GENERAL INFORMATION

Applicant:	Bloomington Central Station LLC c/o McGough Development
Location:	8170 31 st Avenue South
Request:	Preliminary and Final Plat for Bloomington Central Station 5 th Addition; Major Revision to Final Development Plan for a 1,657 stall parking structure and surface parking improvements.
Existing Land Use and Zoning:	Vacant commercial land; zoned High Intensity Mixed Use with Residential (Planned Development) – HX-R (PD) and Airport Runway – AR-17
Surrounding Land Use and Zoning:	North – Park, surface parking and light rail transit right-of-way; zoned HX-R (PD) South – Office and vacant land; zoned C-4 East – Multiple-family dwelling; zoned HX-R (PD) West – Structure parking ramp, office and manufacturing; zoned LX and CO-1
Comprehensive Plan Designation:	South Loop Mixed Use

PROPOSAL

Exhibit 1: Parking Areas for BCS – Health Partners

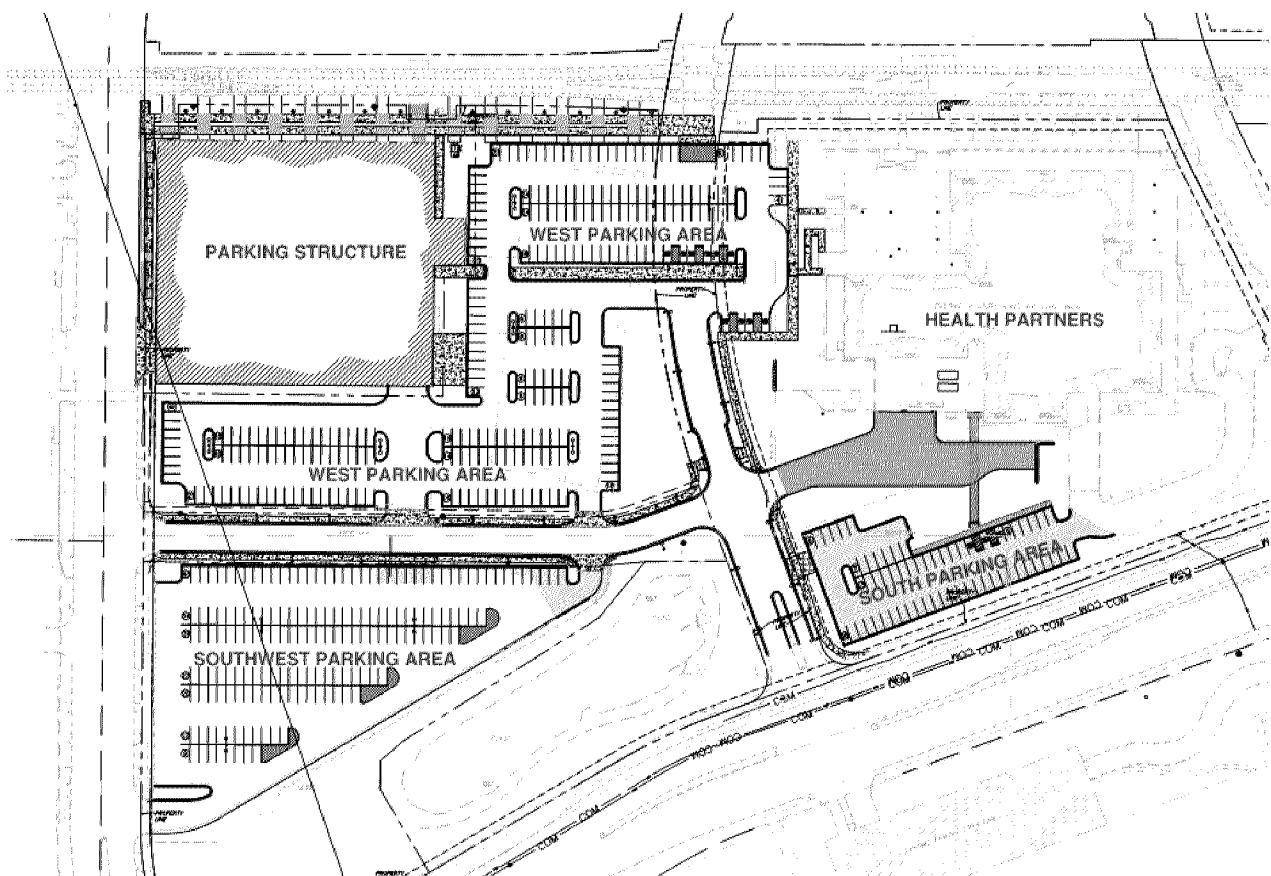
Along with the parking structure, there are three areas of surface parking proposed. See Exhibit 1 for a map identifying the surface parking areas discussed in this report. Each specific surface parking area is proposed to be modified in some fashion from its existing condition.

In addition to parking counts, a summary of improvements to the three surface parking areas is also warranted. Code-compliant landscaping and lighting is planned for both the South and West parking areas, whereas only Code-compliant lighting is planned for the Southwest parking area. The improvements to the Southwest parking area are considered to be more related to parking lot maintenance than permanent development. The temporary parking lots were approved to be constructed in their current condition while awaiting future development. All of the surface parking areas are intended for more permanent development at some point in the future. Nevertheless, the West and South parking areas will be improved to Code-compliant status for the interim period prior to future development.
